MDA Review 3: Specific comments to address

MDA Review 3: Our response

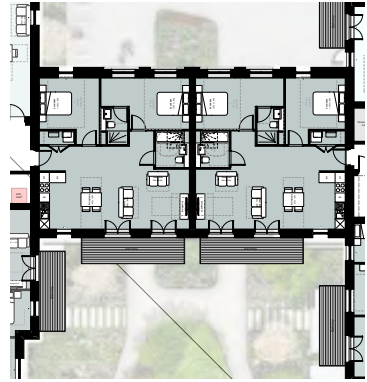
- Clarity required over the servicing strategy to commercial units

- Servicing to commercial units along Manor Road reviewed. Decision taken to retain servicing strategy from rear due to the following;
 - Proximity of commercial frontages to road
 - Restricted parking along Manor Road
 - Proximity to level crossing and safety measure associated with this
 - Conflict of pedestrian movement and vehicle movement if servicing was on Manor Road

Apartment arrangement
November 2019 amendments

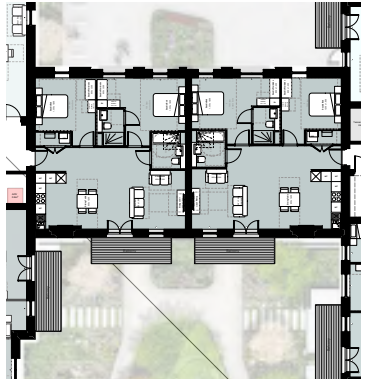
- Thoroughly support the removal of Building E
- Review overlooking of apartments in link buildings
- Consider overheating/shutters/glazing ratio (this can be designed further in stage 3)

- Balconies on link building resized
- Additional window into kitchen/dining room removed to minimise overlooking of adjacent balconies
